HISTORIC AND DESIGN REVIEW COMMISSION

April 17, 2024

HDRC CASE NO: 2024-138
ADDRESS: 331 FURR DR
LEGAL DESCRIPTION: NCB 6698 BLK 7 LOT 8 E 5 FEET OF 9
ZONING: R-6, H
CITY COUNCIL DIST.: 7
DISTRICT: Monticello Park Historic District
APPLICANT: Aaron Longoria | All in Remodeling
OWNER: Alfredo Garcia
TYPE OF WORK: Second story addition modifications and wholesale siding replacement
APPLICATION RECEIVED: March 28, 2024
60-DAY REVIEW: May 27, 2024
CASE MANAGER: Bryan Morales

**REVISED 2nd FLOOR PLAN**
SCALE: 1/4" = 1'-0"

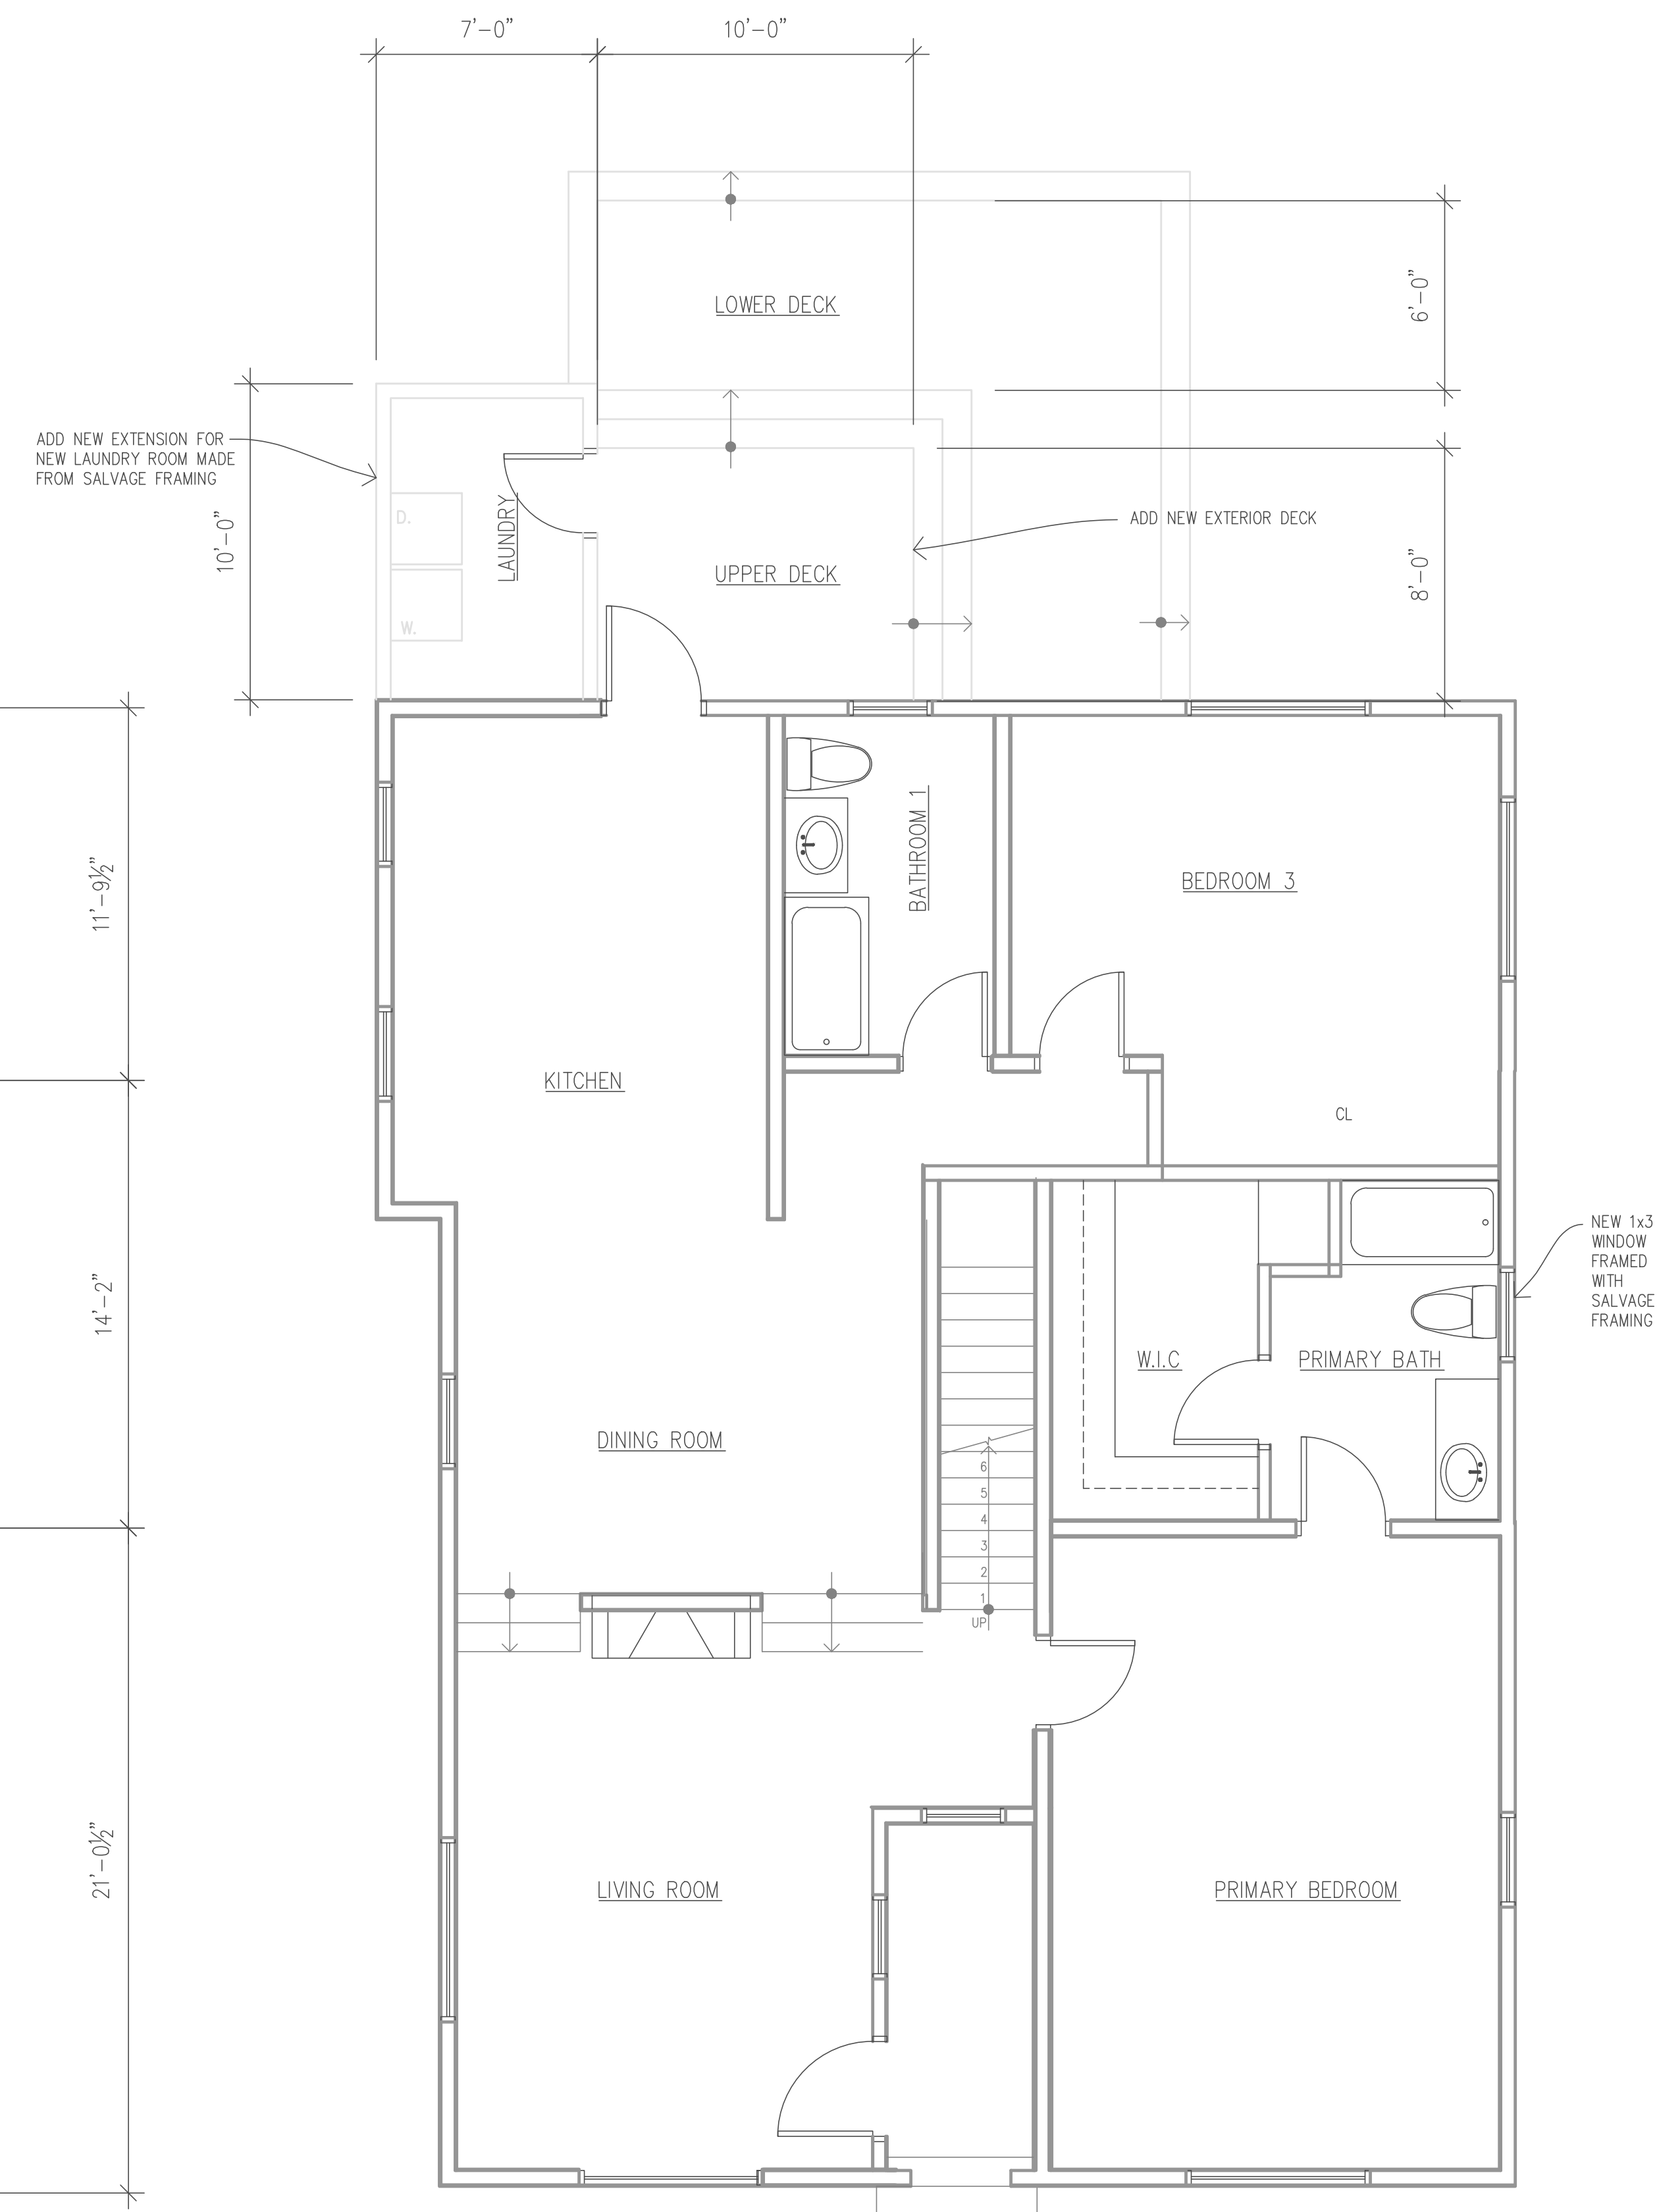
- e. **SECOND-STORY ADDITION EXTENSION** – The applicant is requesting approval to extend the second-story addition's northern wall by three feet to the north without change in fenestration pattern or roof form. The Historic Design Guidelines for Additions 1.A.i. states to minimize the visual impact of site residential additions. Additions 1.B.ii. states to limit rooftop additions to the rear façade. Staff finds the extension of the second-story addition's northern wall generally appropriate.

Staff recommends approval of item 1, based on findings a and e.

1 x 6 x 12 Southern Pine
D&BTR.KD.105 Siding Boards, 12
ft L Nominal, 6 in W ...

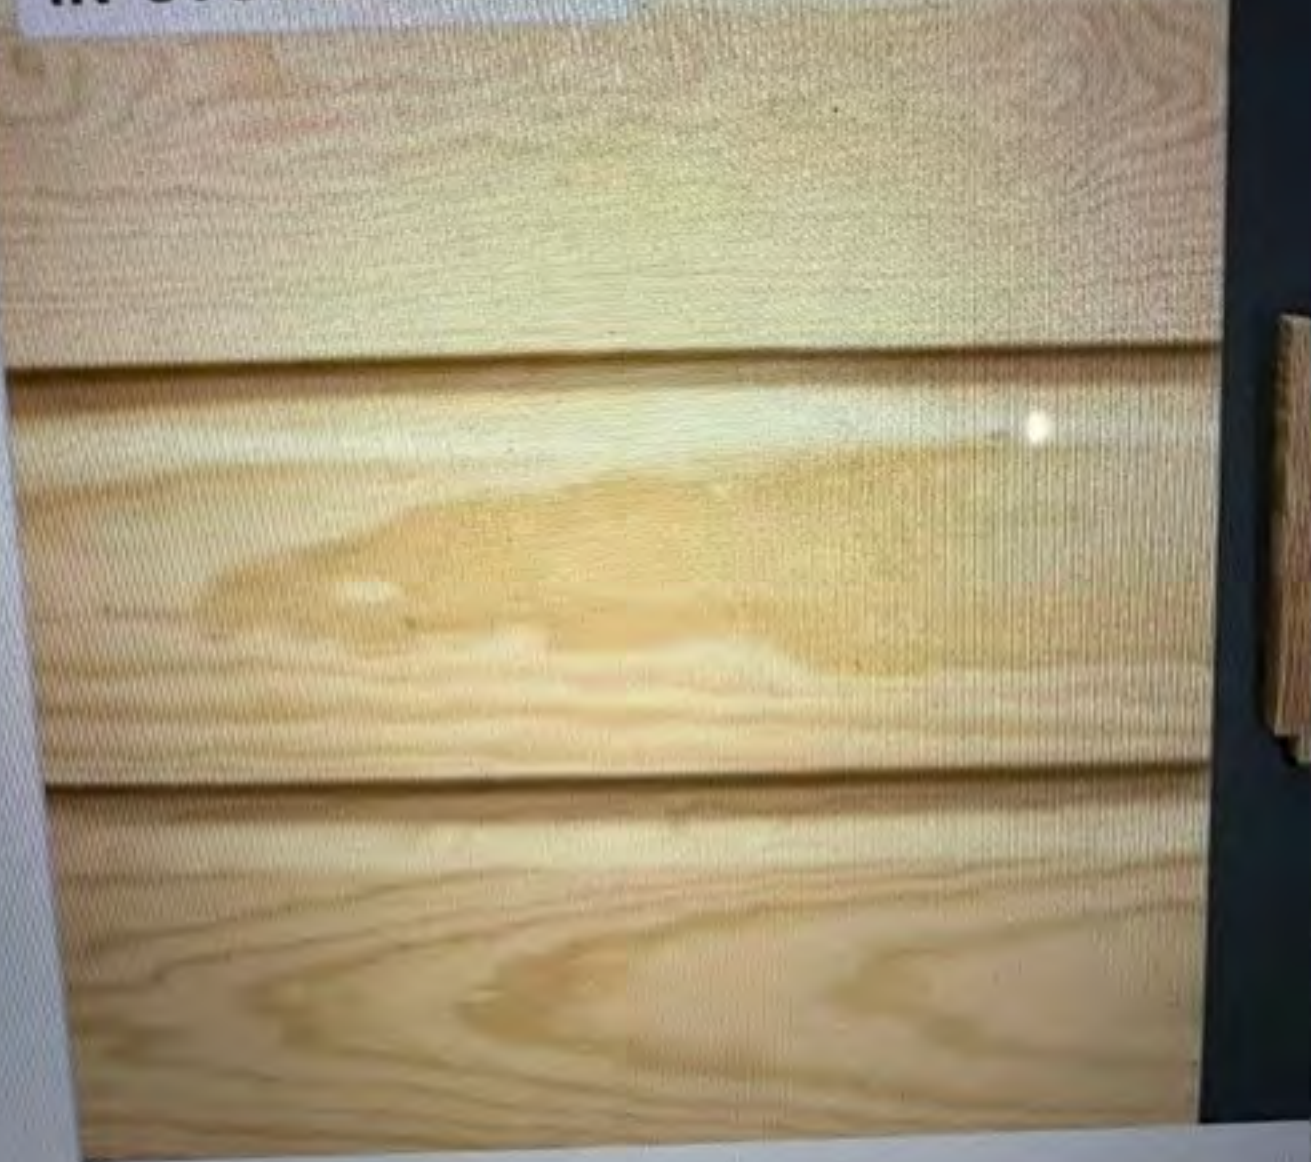
- f. **WHOLESALE SIDING REPLACEMENT** – The applicant is requesting approval to replace the existing wood shake siding with six-inch 105 wood siding or a similar product. The Historic Design Guidelines for Exterior Maintenance and Alterations 1.B.i. states to avoid removing materials that are in good condition or that can be repaired in place, to consider exposing original wood siding if it is currently covered with materials that have not achieved historic significance. Exterior Maintenance and Alterations 1.B.ii. states to use in-kind materials when possible or materials similar in size, scale, and character when exterior woodwork is beyond repair and to ensure replacement siding is installed to match the original pattern including exposures. Exterior Maintenance and Alterations 1.B.iii. states to replace wood elements in-kind as a replacement for existing wood siding, matching in profile, dimensions, material, and finish when beyond repair. Staff finds the request for wholesale wood shake siding replacement with an alternative siding profile does not conform to guidelines.

Staff does not recommend approval of item 2, based on findings a through d and finding f. Staff recommends the applicant replace the wood shake siding in-kind.
